Korana Wind Energy Facility and associated infrastructure, Northern Cape Province

Motivation for amendment of Environmental Authorisation

DEA Ref.: 14/12/16/3/3/2/682

September 2019

Figure 5.1: The position of known a **Martial Eagle** nest and a 4.5km buffer around the nest, relative to the proposed site. **(A3 Map included in Appendix F).**

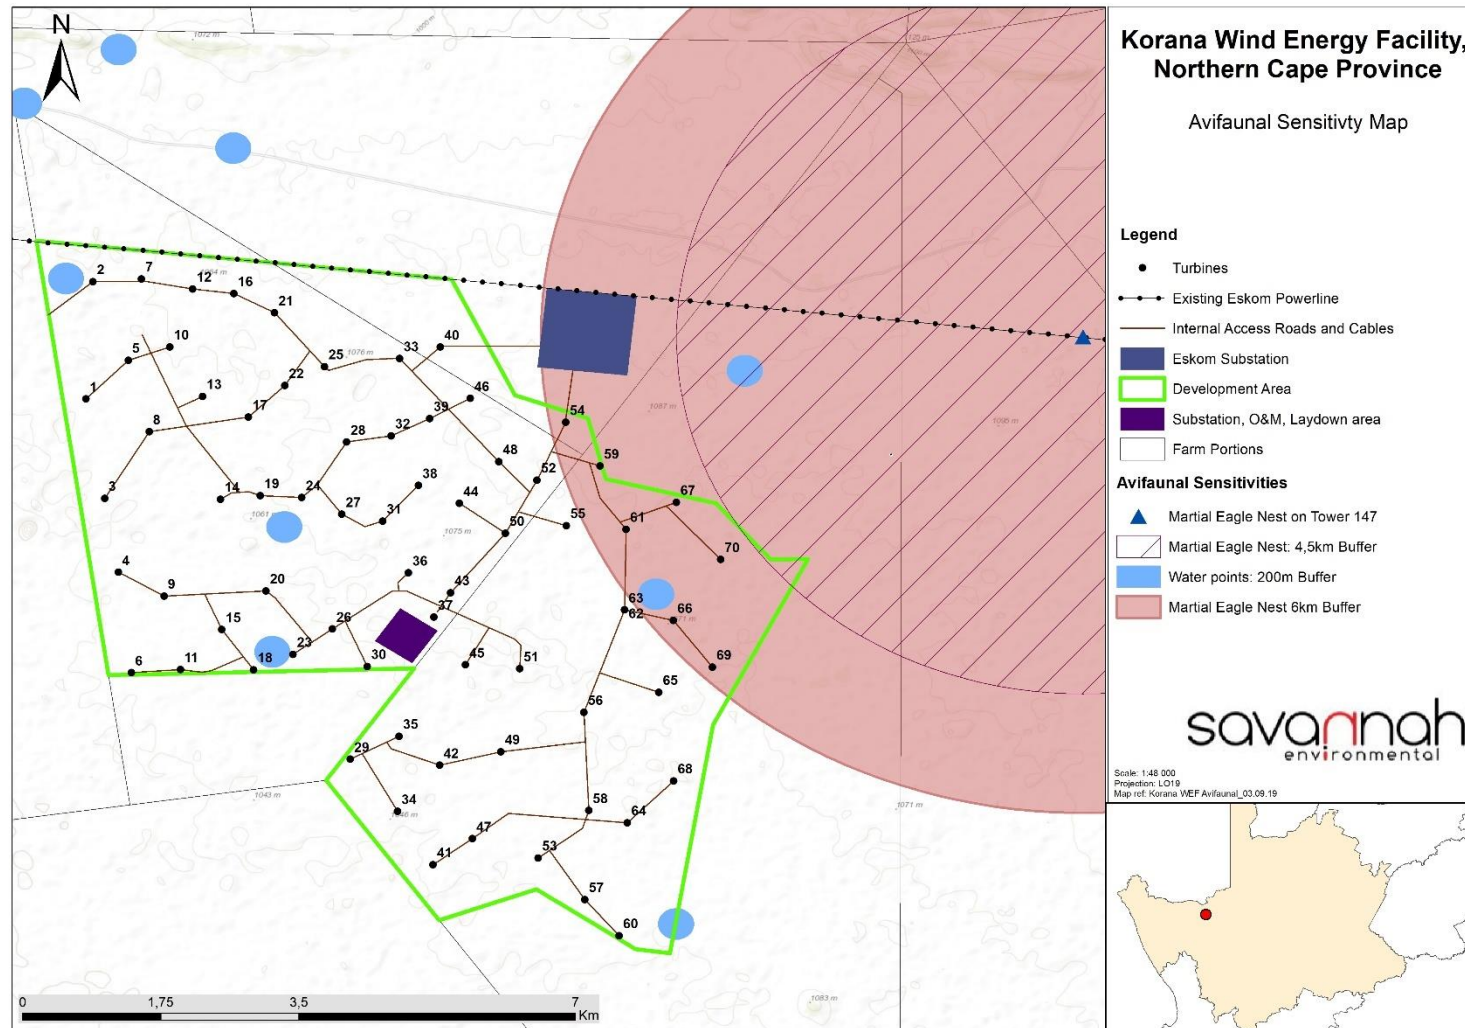
Two known Martial Eagle nests were identified during the EIA phase. The Verreaux's Eagle nests are indicated relative to the Korana Wind Farm in Figure 5.1.1. The previous 1.5km turbine-free buffer zone around the Martial Eagle nest on Tower 147 of the Aries – Aggeneys 400kV 1 transmission line was converted to a 4.5km turbine-free zone. This was done to bring the WEF closer in line with recent guidelines. This is indicated in Figure 5.1.1 below.

The nest searches conducted in July 2019 confirmed the presence of a Martial Eagle nest on Tower 147 of the Aries – Aggeneys 400kV 1 transmission line, which runs north of the project area. The average territory size of a large eagle represents an important area which can contribute to conservation planning and should be considered the absolute minimum area for conservation (Ralston-Patton 2017). Global Positioning System (GPS) tracking of Martial Eagles in the Kruger National Park indicates average territory sizes of 110km² (Percy Fitzpatrick Institute 2015), which equates to a 6km circular zone around the nest. Given the proven vulnerability of the species to wind turbine collisions which is now firmly established, 5-6km should ideally be taken as the desired turbine-free buffer zone around a Martial Eagle nest².

- » The number of turbines should be reduced to a maximum of 42 turbines (i.e. 60% of the original authorised 70).
- » The 1.5km turbine-free buffer zone around the Martial Eagle nest on the Aries – Aggeneys 400kV 1 transmission line should be converted to a 4.5km turbine-free zone, and the number of turbines beyond the 4.5km turbine-free zone, up to a radius of 6km from the nest, should be restricted to no more than 13.
- » As an absolute minimum, post-construction monitoring should be undertaken for the first three years of operation, and then repeated again in year 5, and again every five years thereafter. The exact scope and nature of the post-construction monitoring will be informed on an ongoing basis by the result of the monitoring through a process of adaptive management.

Figure 5.2: Potential roosts on the Korana WEF and designated buffers of 300 m and 500 m around these roost sites. **(A3 Map included in Appendix F).**³

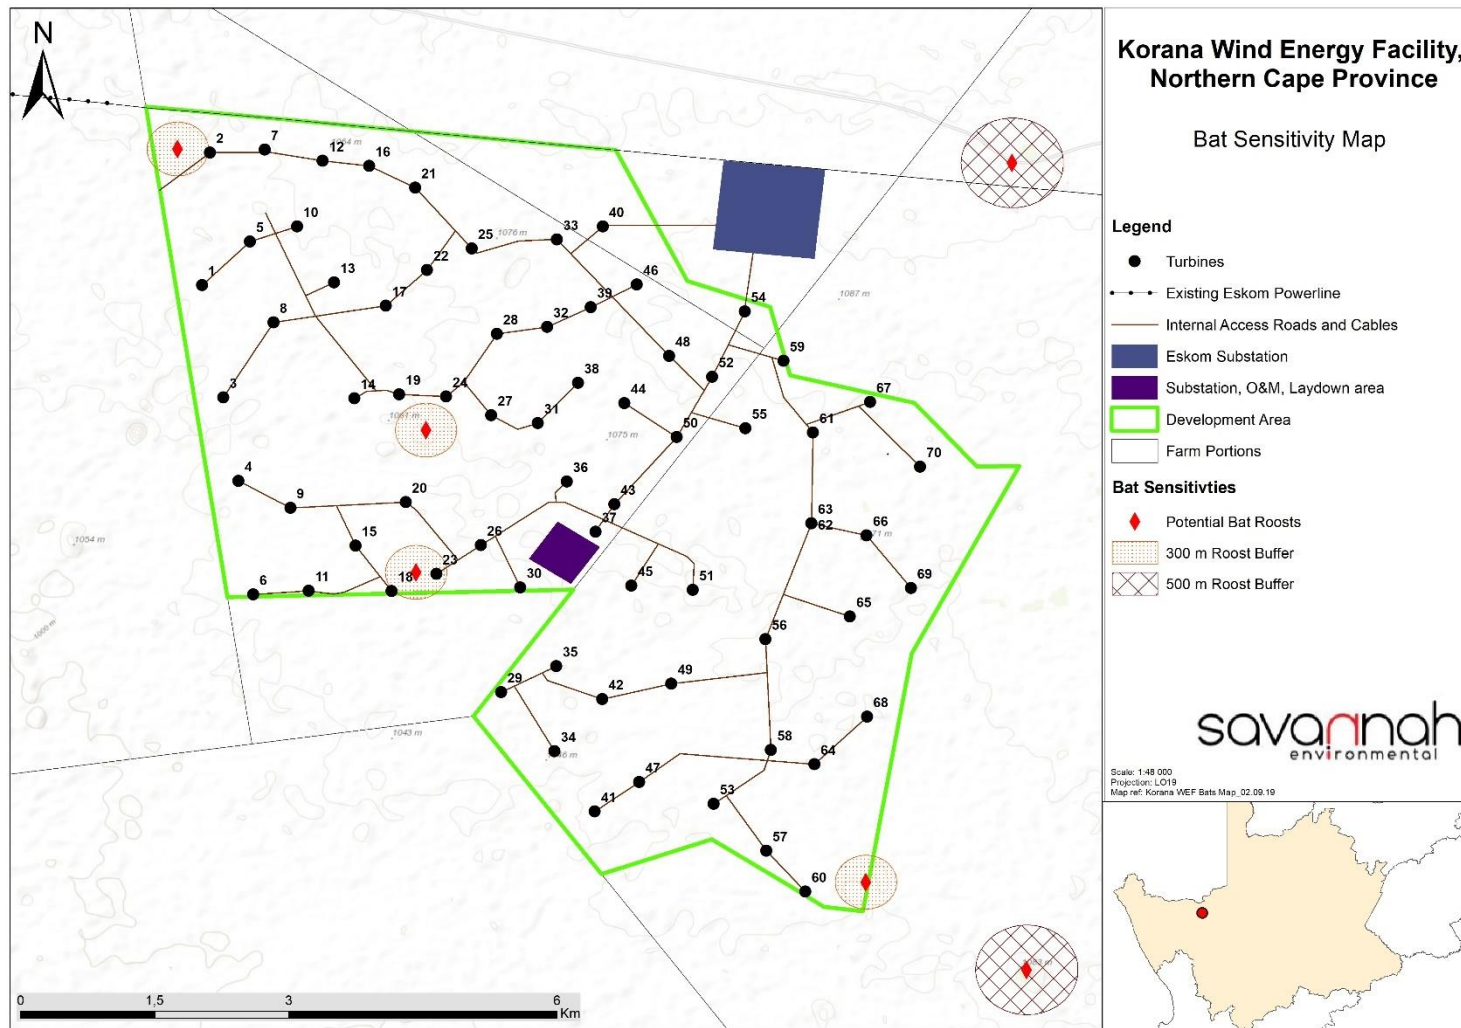
The bat monitoring report identified potential roosts on site and designated buffers of 300 m and 500 m around them (Arcus Consultancy Services, 2014). Siting of turbines, and other construction activities, in these buffers should be avoided. For this amendment, all components, including the turbine blade tips, must be excluded from entering the buffer areas. The turbine layout should be approved by a bat specialist upon finalisation of turbine specifications. Refer to figure 5.2.1 below for the bat sensitivity areas.

³ The layout shown above consists of 70 turbines and a few turbines are currently located within the roost buffers. These turbines will however be excluded from the layout when the layout is finalised at a later stage (prior to commencement of the activity).

must be implemented upon construction. The turbine layout must adhere to the sensitivity areas and buffers. All components, including the turbine blade tips, must be excluded from entering the buffer areas and these distances must be revised and calculated with the amended turbine sizes. The impact assessment ratings will remain as in the EIA report on condition of implementation of the above-mentioned mitigations.

Figure 5.3: Viewshed analysis represents the potential total visual exposure of the original turbine dimensions (illustrated in green) compared to the proposed new turbine dimensions (illustrated in red).⁵

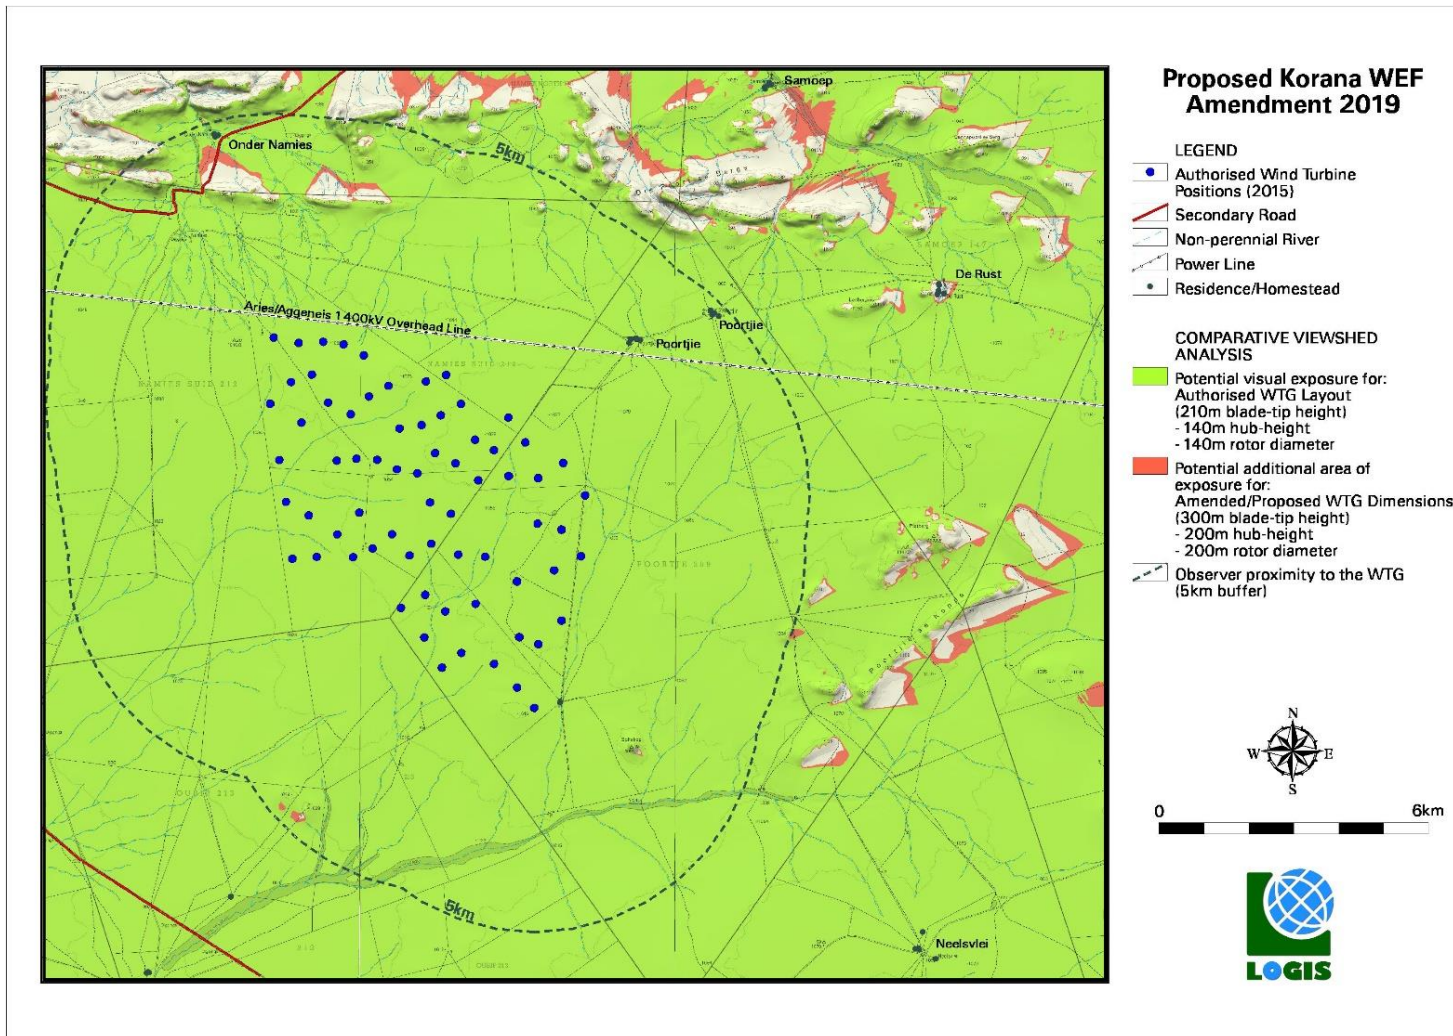
A visibility analysis was undertaken from each of the wind turbine positions (70 in total⁴) at an offset of 210m (maximum blade tip height) above ground level. The result of this analysis represents the potential total visual exposure of the original turbine dimensions (indicated in green). The viewshed analysis was repeated at an offset of 300m to indicate the visual exposure (shown in red) of the increased turbine dimensions. The results of the visibility analyses are displayed on Figure 5.3.

It is expected that the wind turbine structures, both the original dimensions and the proposed increased dimensions would be equally visible and noticeable from both the roads and homesteads identified above, therefore signifying a negligible change to the potential visual impact.

Figure 5.4: NSD in relation to the wind turbines of the Korana WEF (refer to **Appendix F** for A3 Map).⁶

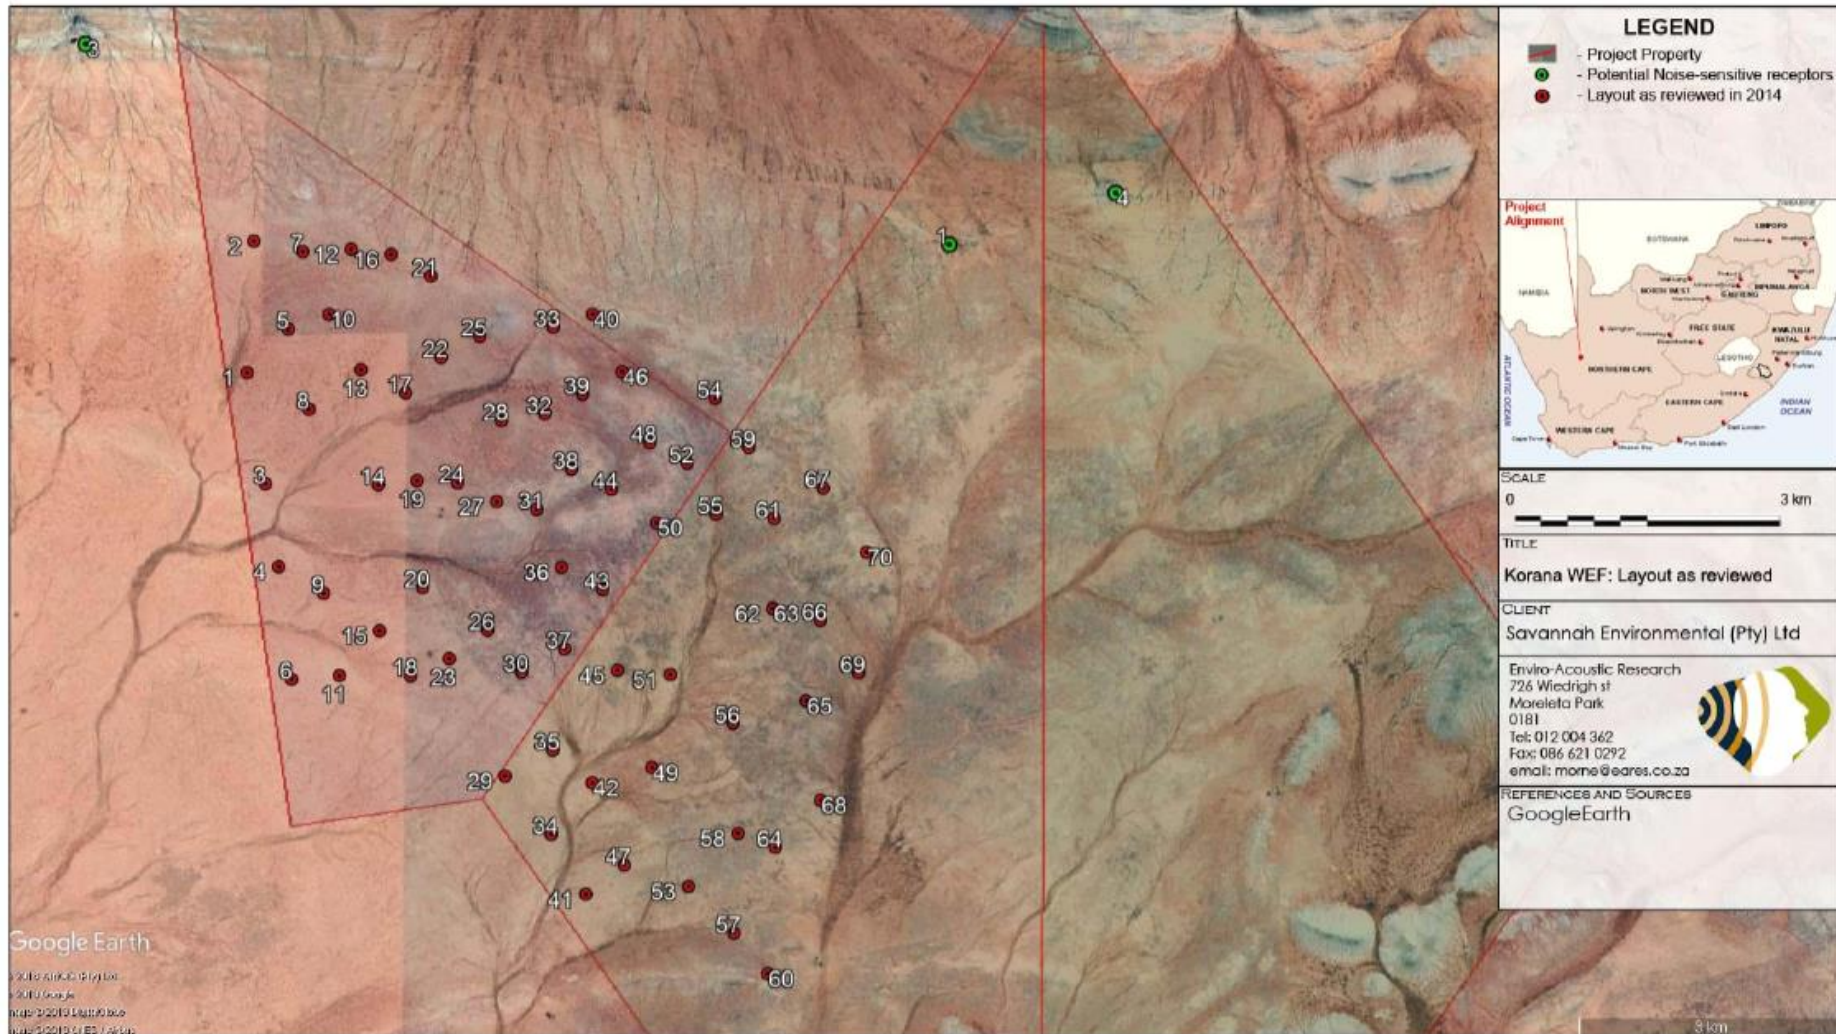
The noise amendment comment letter (**Appendix D**) addresses the potential changes in noise impact significance in terms of the proposed amendments by comparison with the original assessment undertaken in 2014 as part of the EIA process. The 2014 Noise Impact Assessment indicated that the proposed wind farm will have a noise impact of a low significance on all Noise Sensitive Developments (NSDs) in the area during both the construction and operational phases using the Vestas V117 3.3MW wind turbine for all wind speeds. This wind turbine has a maximum sound power generation level of 107.0 dBA. The projected maximum noise levels would be less than 35 dBA at the closest NSD. These NSDs are shown in Figure **5.4** below.

Considering the fact that proposed wind turbines are more than 2000m away from any potential noise-sensitive receptors and taking into account the potential noise impact, the specialist concluded that the change will not alter (i.e. increase or decrease) the significance of the noise impact and the impacts will remain of a low significance. The amendment is acceptable from a noise perspective and no additional mitigation measures are required.
